CAMDEN GOODS YARD

BUILDING A TECHNICAL FACADE REPORT

0.0.1 INTRODUCTION
This report contains technical analysis and comment on the post planning developed facade design of Building A at Camden Goods Yard. It includes the consented detailed facade drawings for reference together with analysis of the facade mockup panel and design changes introduced by delivery architects PTAL during RIBA Stage 4.

3.1
SAMPLE PANEL: BRICK OPTIONS

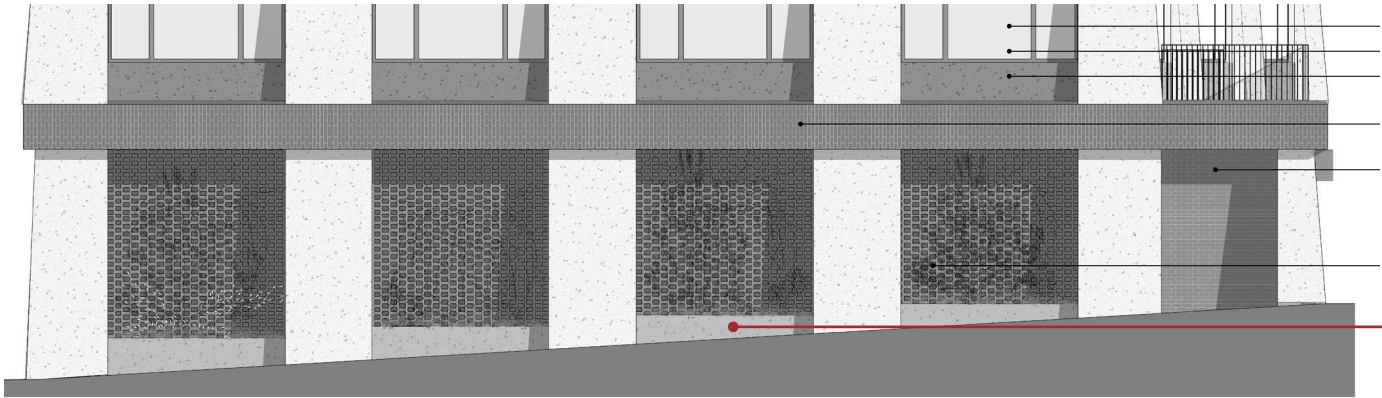
With regard to the brickwork the description on the detailed planning drawings reads “Dark grey textured rustic brick soldier coursing horizontal bands with 430mm soffit overhang to windows”. The developed detail design has increased this to 470mm which in the context of previous discussions with the planners is a positive move.

Of the remaining three bricks we consider that Brick Option 01: Hechisch Zwarte (Agita Black) and Brick Option 02: Wienerberger Graphite Black represent a good match to the planning visuals and the ‘Dark grey textured rustic’ qualities described on the planning drawings.

However, it is our understanding that Brick Option 01 is significantly over budget and that the client wishes to discard this as an option.

Brick Option 03: Michelmersh Black Smooth has a finish which is too smooth, shiny and consistent to be considered as ‘rustic’ or ‘textured’.

The mortar should be raked joints and matched in colour to the chosen brick.

Window frames and balustrades are to be a dark grey finish. We would suggest RAL7022.

SOUTH WEST FACADE GROUND FLOOR: CONSENTED PLANNING DESIGN

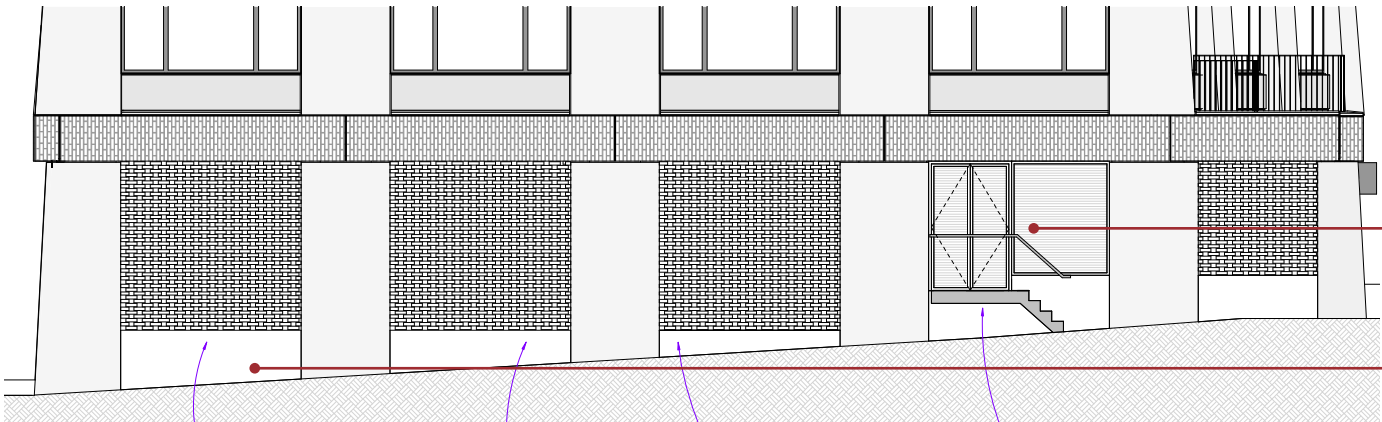
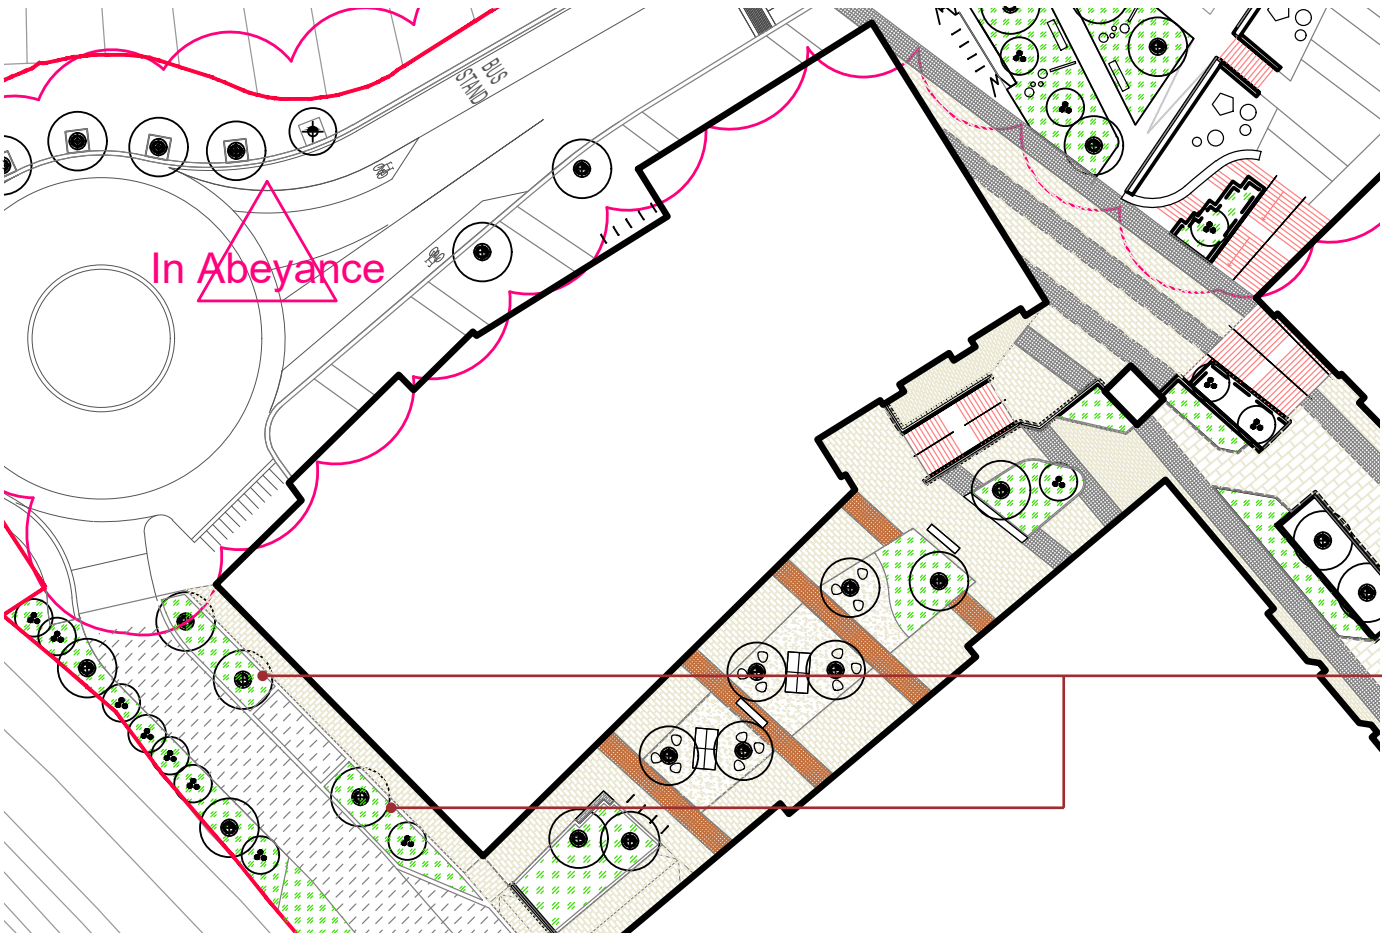
SOUTH WEST FACADE GROUND FLOOR
The concrete planters at the base of the facade have been moved away from the hit and miss brickwork and relocated on the edge of the pavement. This is considered a minor and acceptable change but does mean that the potential for plants to climb up the hit & miss brickwork is removed. The concrete planters are marked as being a 'mid-grey' tone in the planning drawings. We are suggesting that for consistency they should be specified to match the darker grey coping and under-window concrete panels on Building A. A more major change is the introduction of metal steps and a plantroom door in one of the bays. It is understood that the current external stair up to the first floor terrace may be removed. If this is the case we suggest that the steps and the door are relocated inside. If this is not possible the steps and door should be powder coated in a dark finish to match the Building A window frames.

NORTH WEST FACADE GROUND FLOOR: CONSENTED PLANNING DESIGN

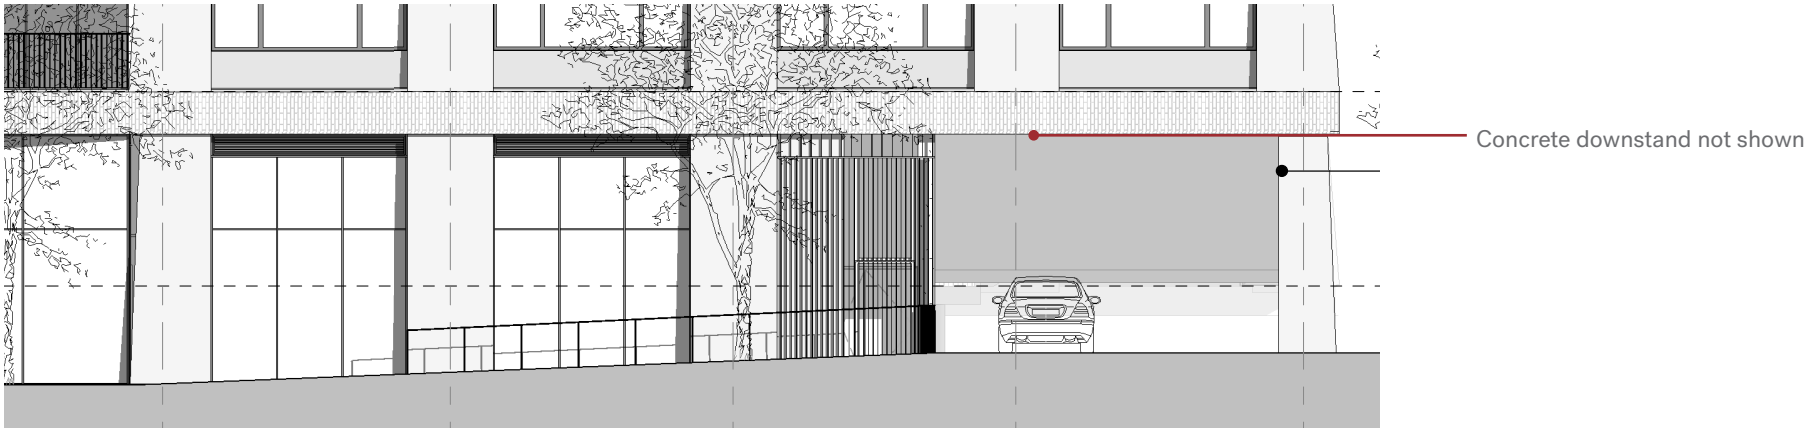
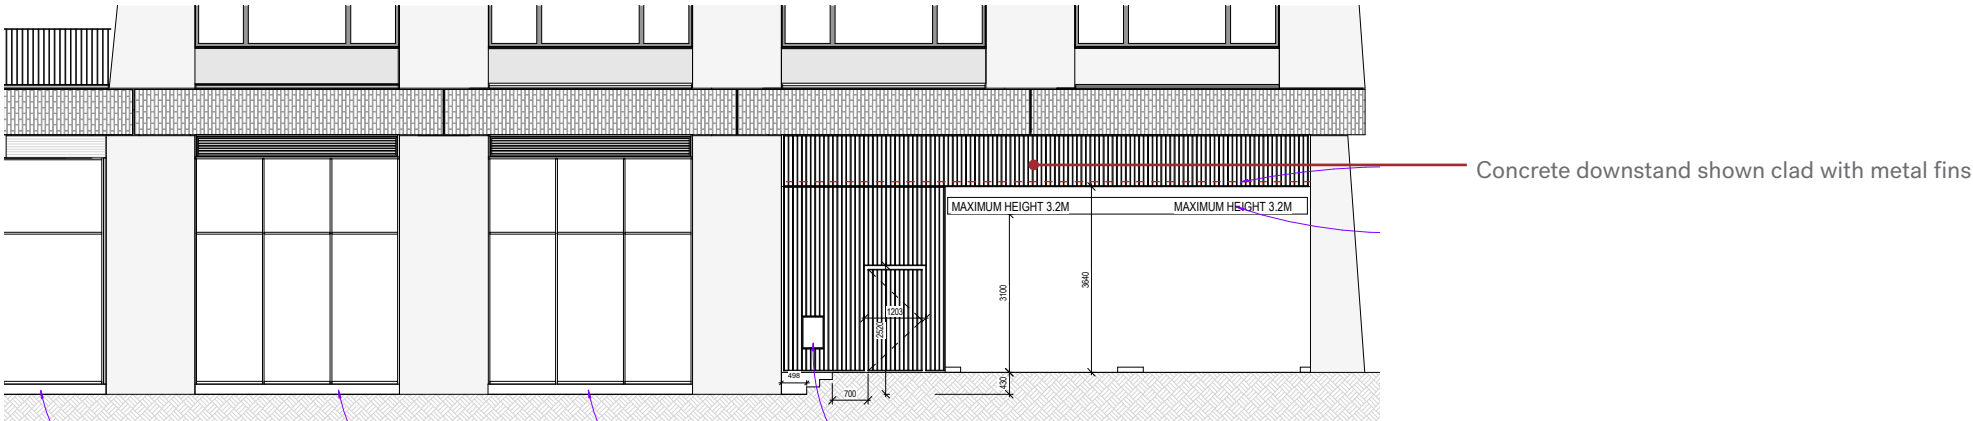
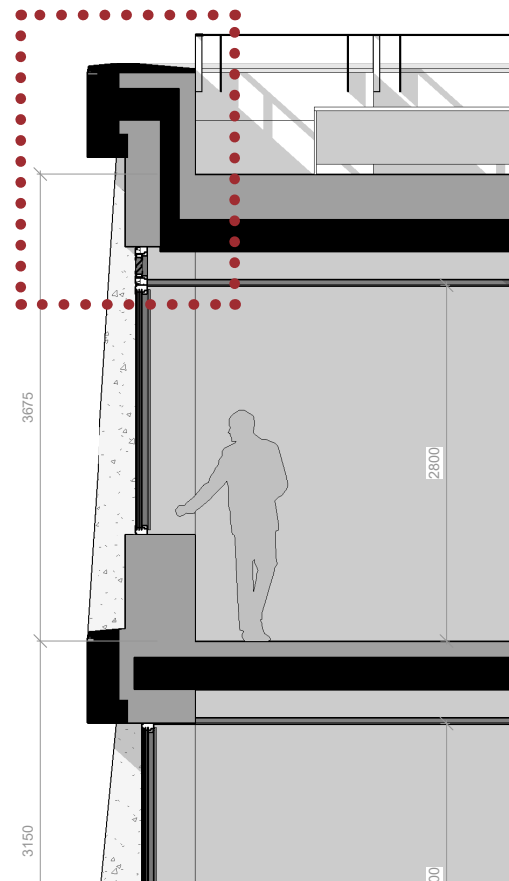
NORTH WEST FACADE GROUND FLOOR
The planning elevations did not show a downstand beam above the entrance to the car park ramp. This is required and PTAL are proposing that the metal gate steel uprights are continued up and over to form a screen to this exposed structural element. We consider this a minor change and a positive one that improves the elevation. 150mm upstands have been introduced under the large ground floor windows. This reduces the likelihood of leaks and the lower windows getting dirty and again is considered a minor and necessary update.

PARAPET DETAIL:
CONSENTED PLANNING DESIGN

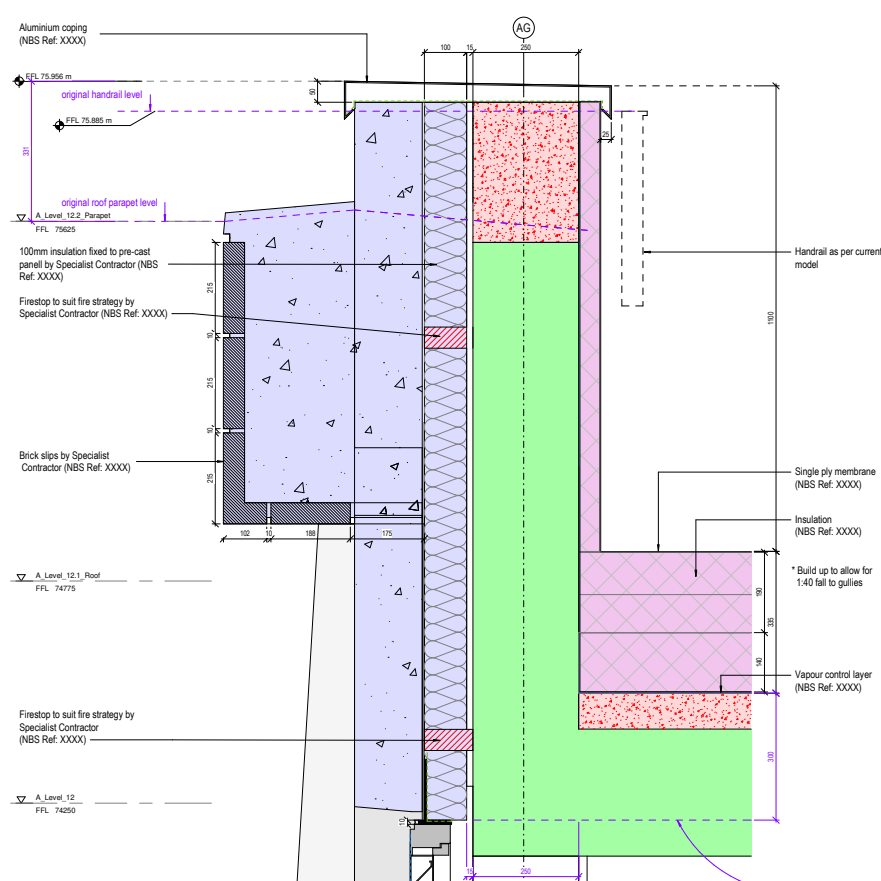
ROOF DETAIL
A small, set back concrete upstand has been introduced at roof level to create a better capping detail and simplify the balustrade design around the roof. The height of this new element is the same as the balustrade shown on the planning drawings. The set back means that this element will not be visible in the short views to the building and will not be prominent in the long views due to its relatively small size. An alternative detail to minimize the apparent height of the upstand would be to add a further brick (215mm) to the top brickwork band.
